Rampion 2 Wind Farm

8.54 Applicant's Responses to Examining Authority's First Written Questions (ExQ1)

Application Reference: 8.54

Figure H-1 Piling exclusion zone for the piling of monopiles, with 20dB reduction (Unwtd 135dB SELss)

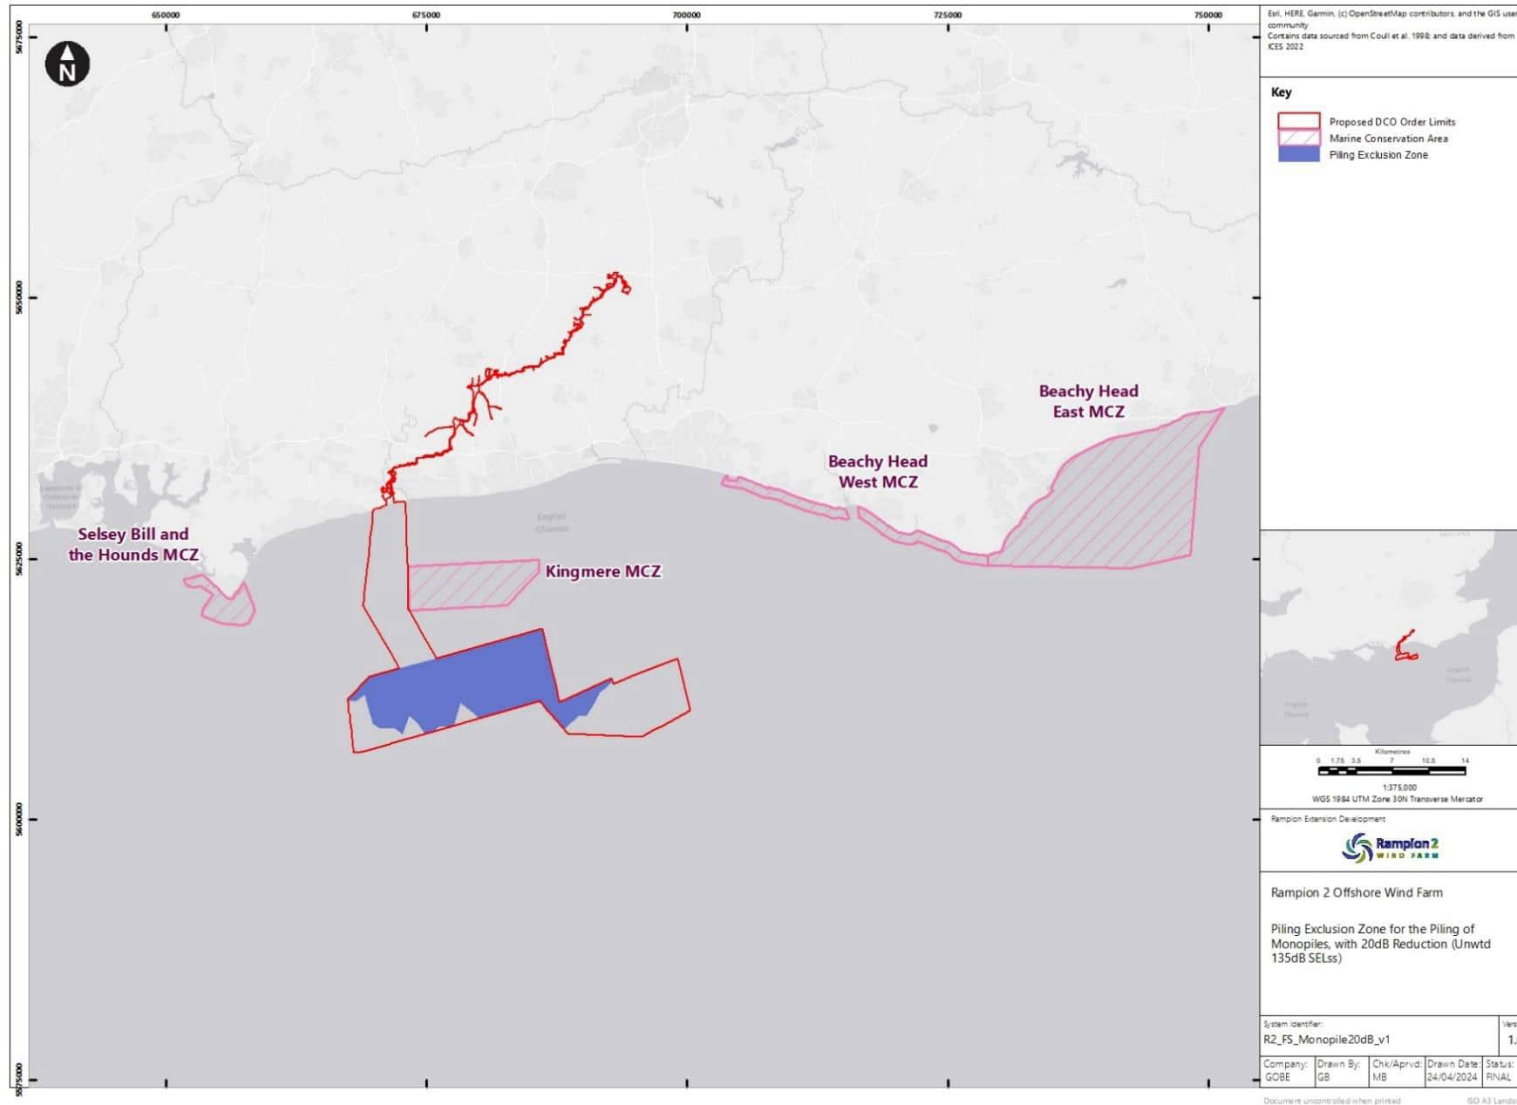
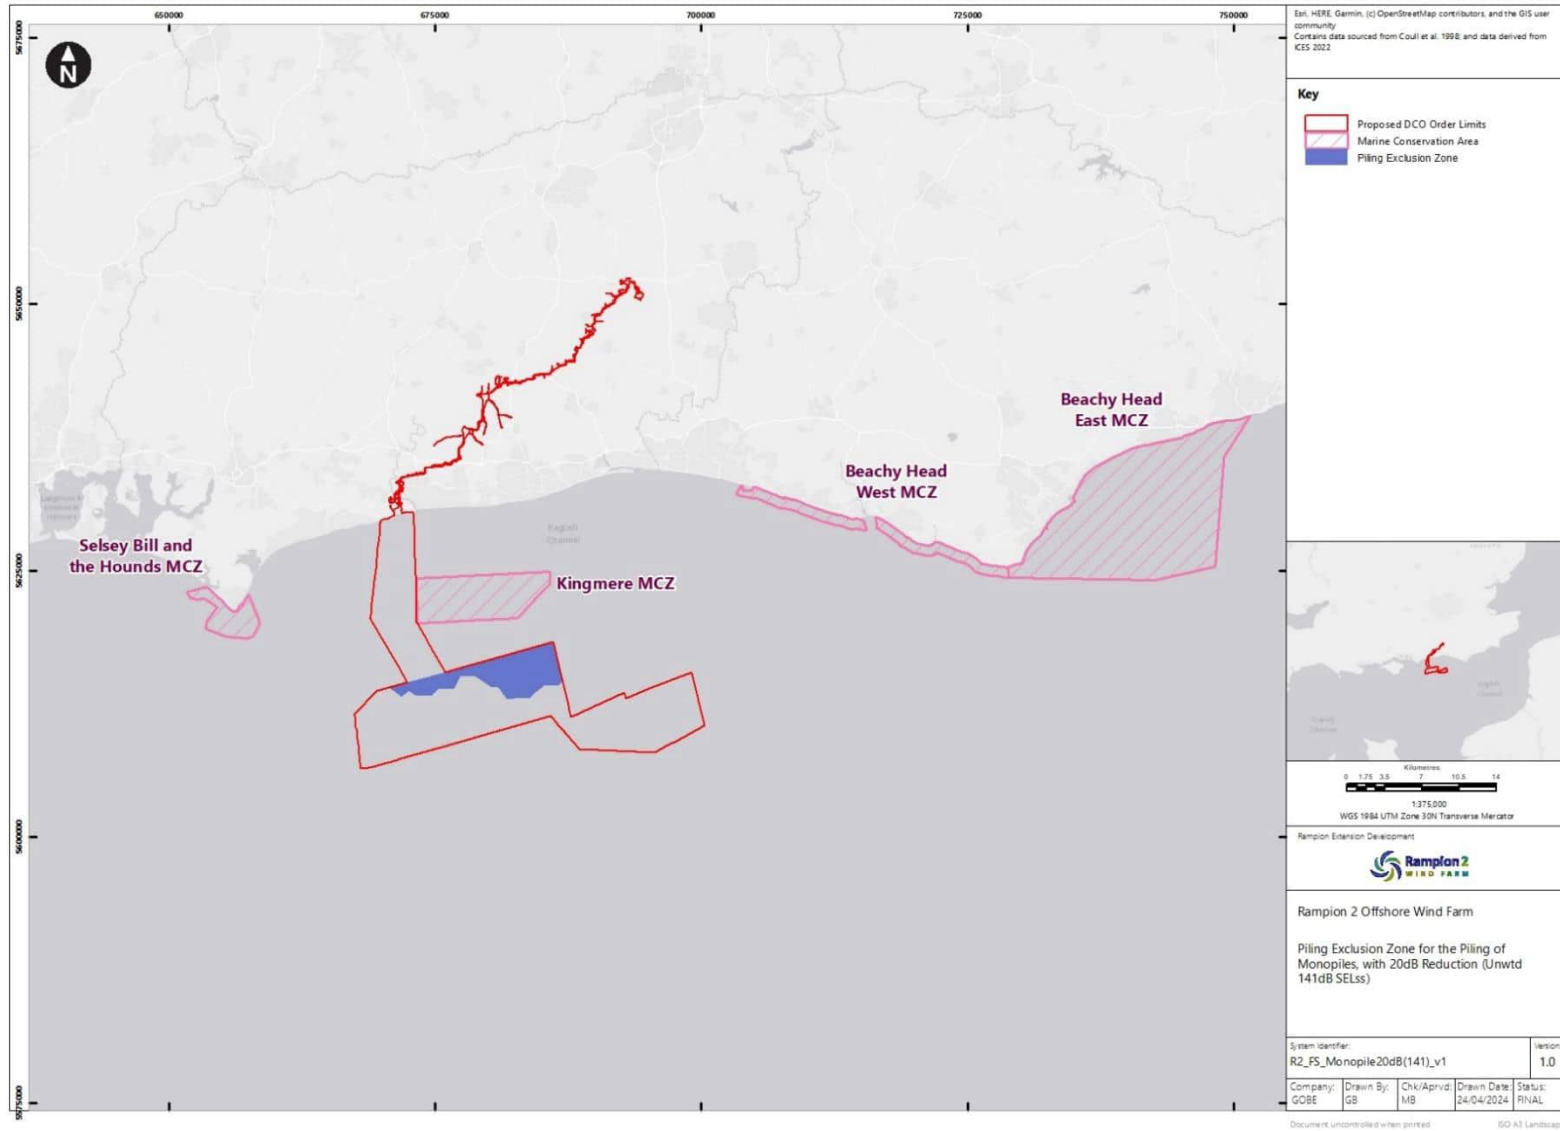
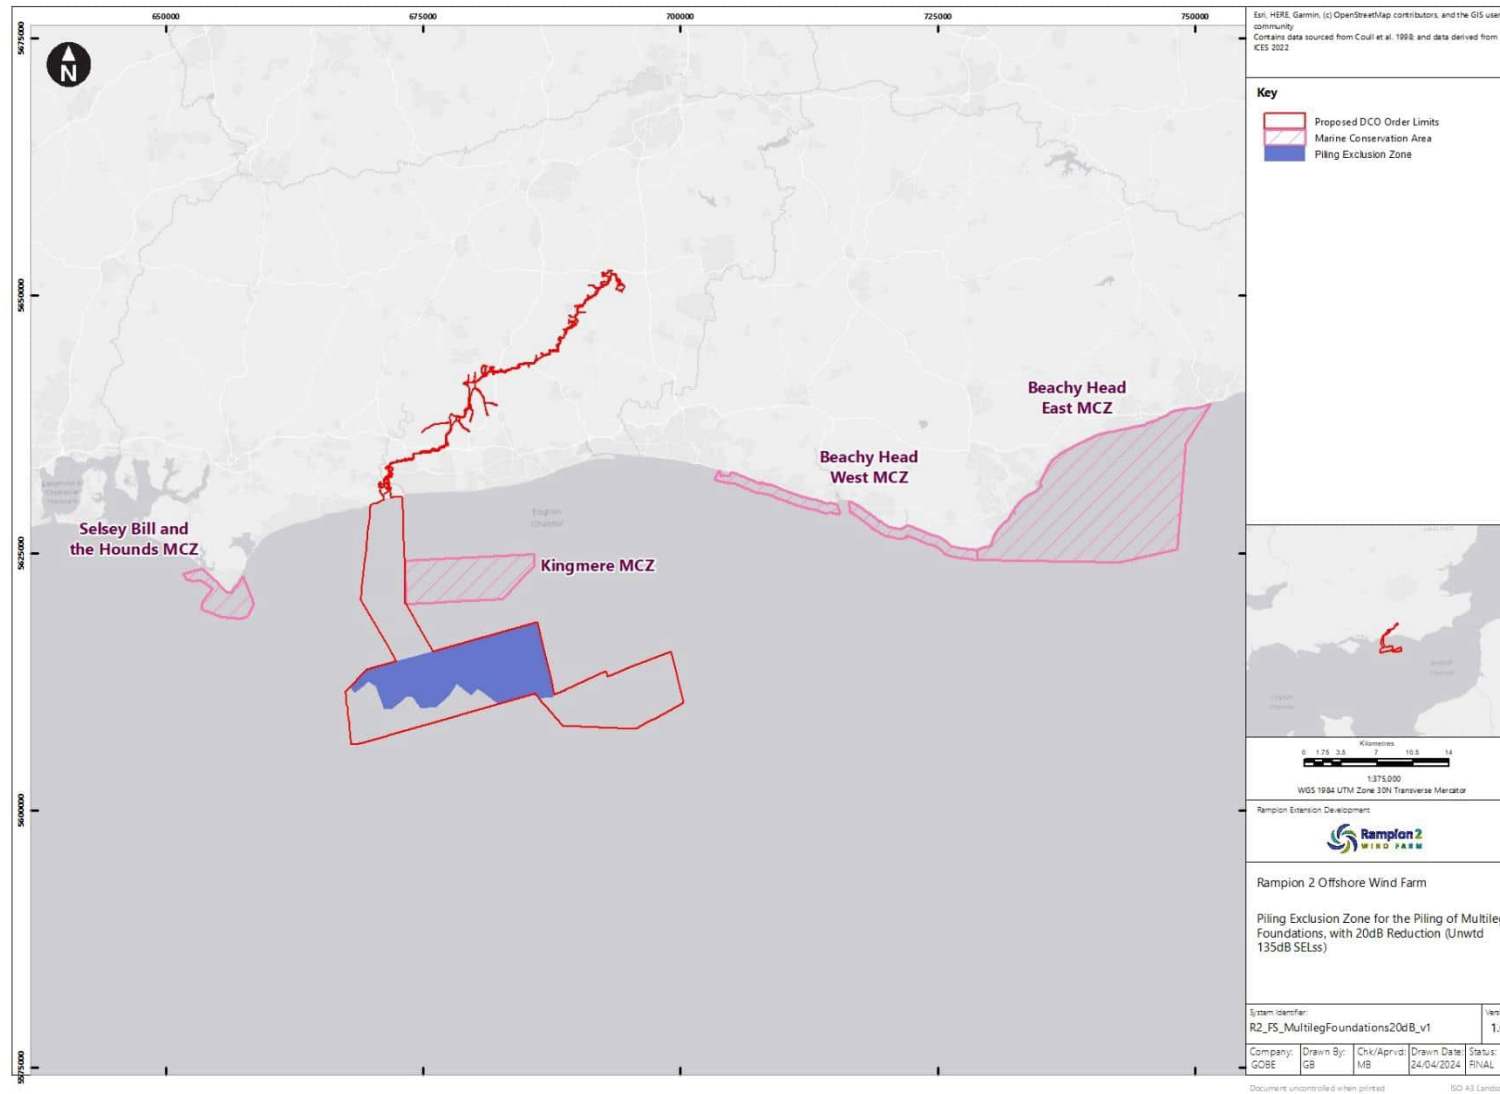
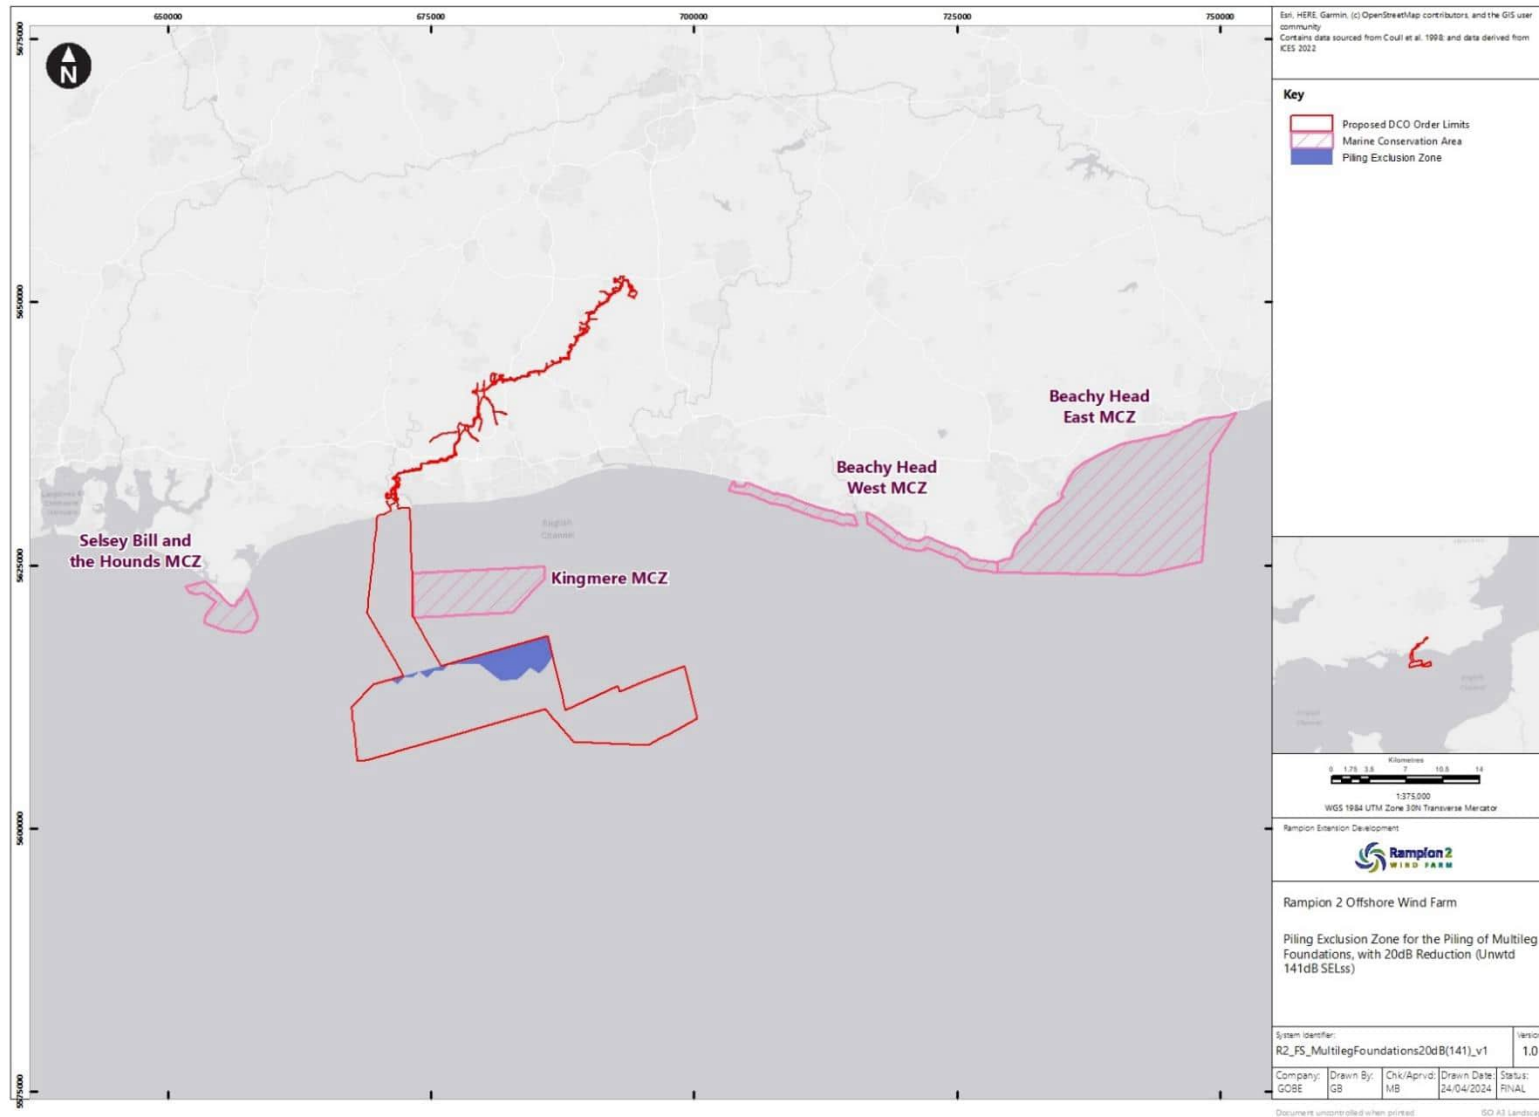
Taking this forward and using the assumption of the maximum design scenarios for both monopile and multileg foundations, Figure H-1 to Figure H-4 show the Rampion 2 boundary alongside the Kingmere MCZ, with the Beachy Head East and West MCZs and the Selsey Bill and the Hounds MCZ also presented for information.

It is clear from Figure H-1 to Figure H-4, to achieve a level of received noise no more than 135dB SELss at the Kingmere MCZ site, the piling of multileg or monopile foundations with the implementation of DBBC + PULSE or MNRU hammer mitigation (20dB mitigation) results in significant piling exclusion zones being required across the western portion of the array area.

As evident in Figure H-1 and Figure H-2, the piling of monopile foundations with 20dB mitigation results in a substantially larger piling exclusion area in the northern section of the offshore array area for the 135dB SELss threshold in comparison to 141dB SELss. Due to the reduced hammer energy when piling multileg foundations, compared to that of monopiles, the impact ranges are smaller under the same mitigation scenarios, therefore the defined piling exclusion zones are also smaller (Figure H-3 and Figure H-4), though again the use of the 135dB SELss behavioural threshold (which is not applicable for a noisy environment such as the English Channel) to inform the zoning exercise has led to the definition of significantly larger piling exclusion zones than those defined using the 141dB SELss threshold. The Applicant highlights that the exclusion zones resulting from the 135dB SELss target noise level, which encompass the majority of the western array area, will have significant implications on the mitigation measures proposed in the **In Principle Sensitive Features Mitigation Plan [REP1-012]** (updated at Deadline 3), and consequently the, piling programme. Such implications are detailed below.
